Cannery Station

PUD Phase 1 Final Subdivision Plat

PC 21 20 SUB 01

Phase 1- Final

Proposed Phase 1 Final Plat

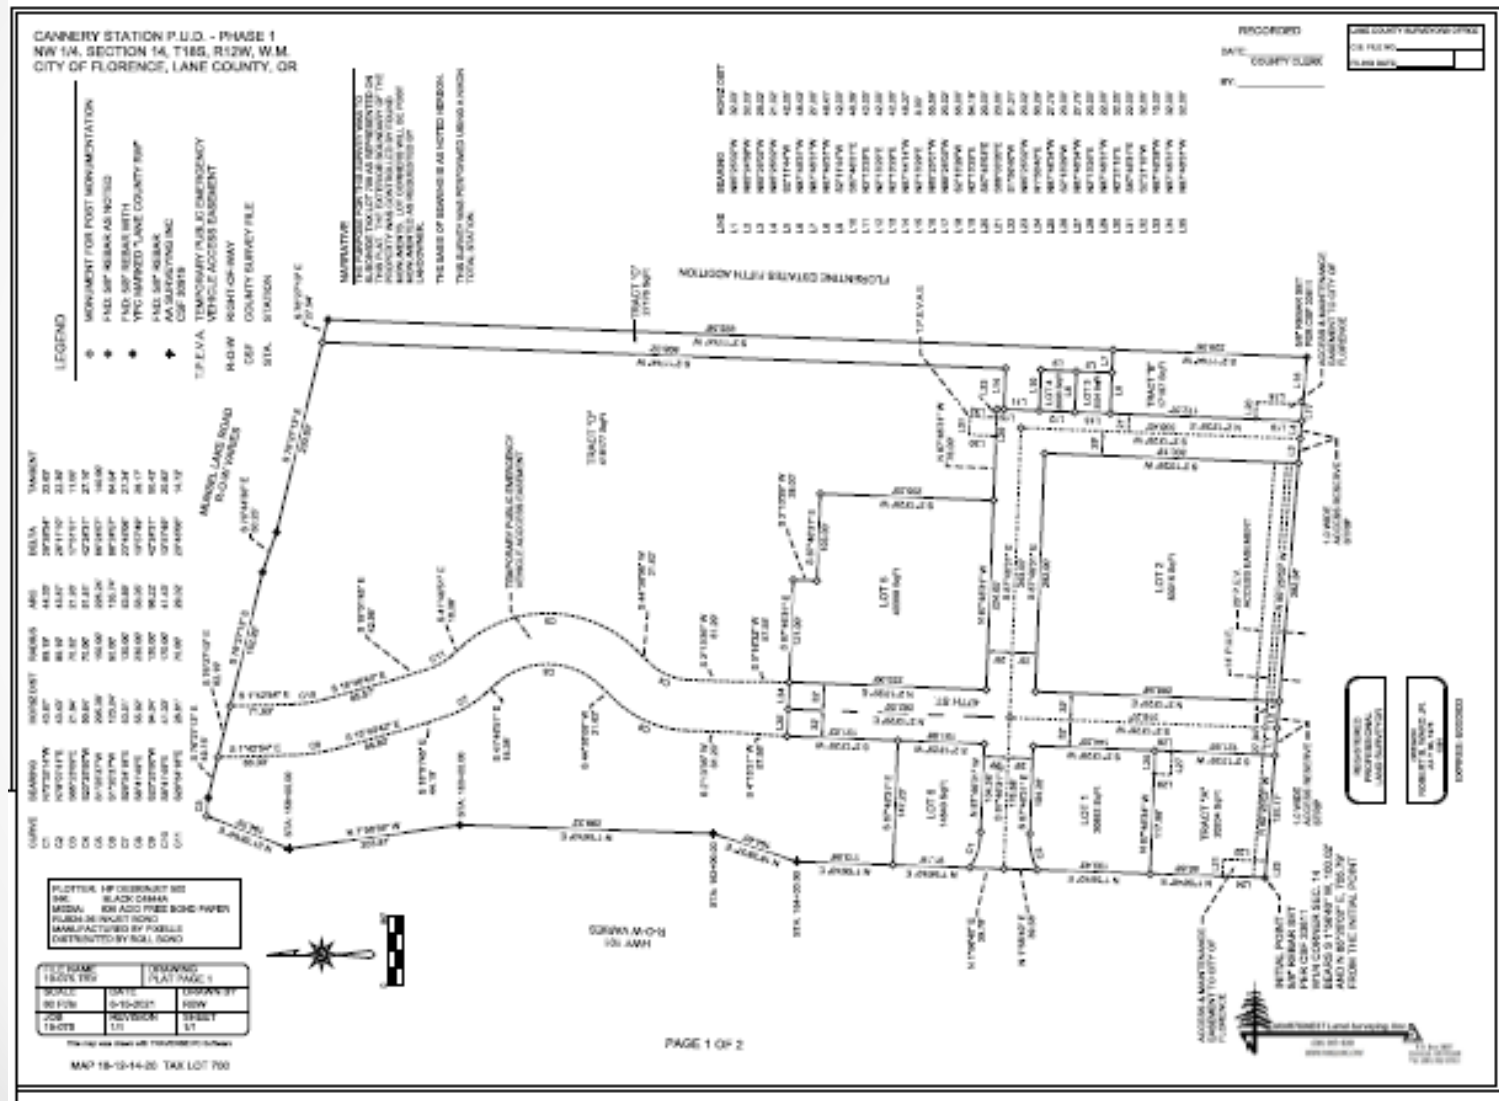
4. Streets are mislabeled and need to be labeled on plat.
5. Show all public utility easements on plat
6. Correct plat notes – not consistent with what is shown.
7. Submit letters of approval from ODOT and County approving temporary access point.

FIGURE
6

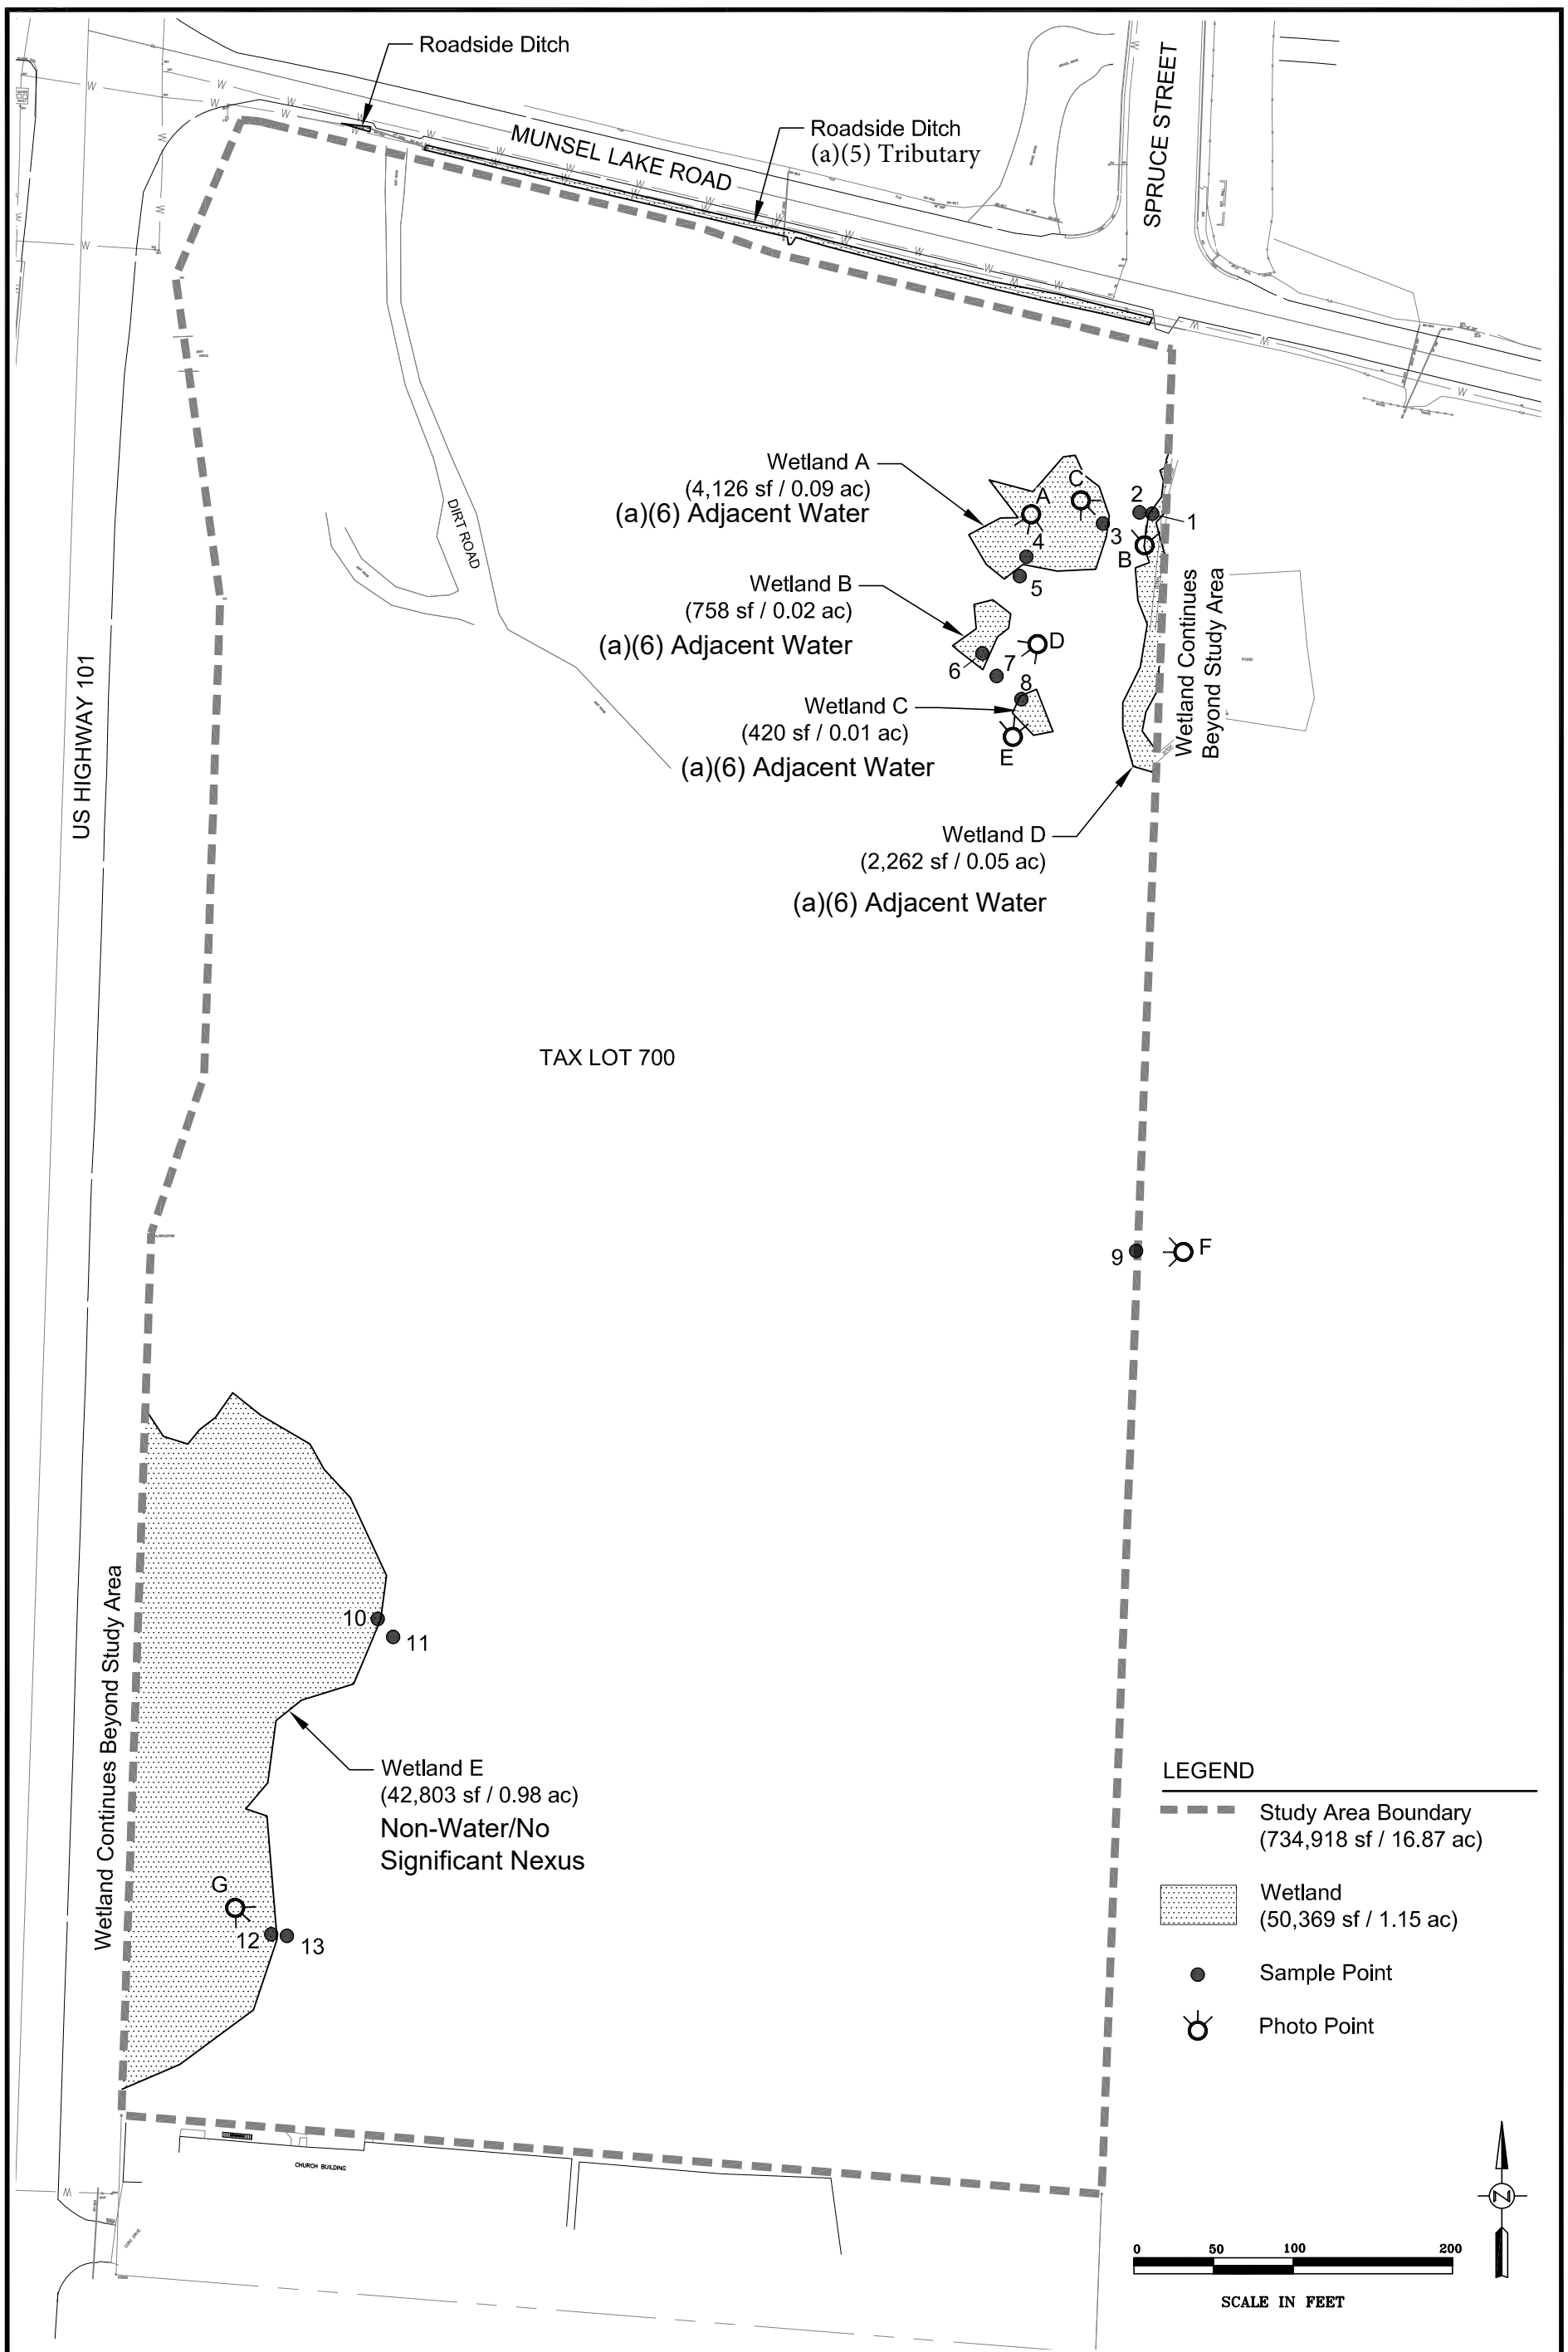
Wetlands on Site
